Date: June 19, 2017

Subject: 12-1/4" Magnet Update

PRODUCT BULLETIN #388

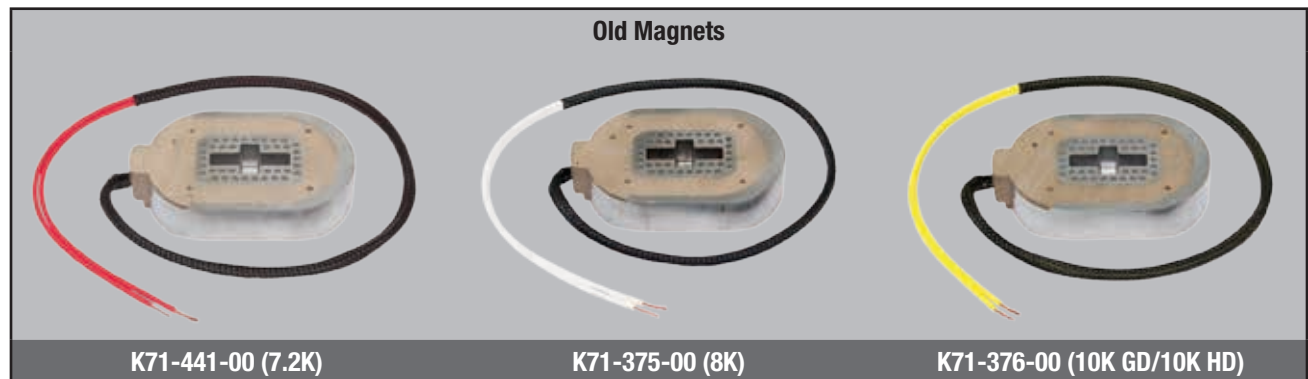
The new 12-1/4" magnet can be identified by a black and red magnet wire (see picture below). The new magnet design is also completely interchangeable with current magnets, and will be a running change in both finished product and kits moving forward. As with all magnets, they should be replaced in pairs – both sides of the axle.
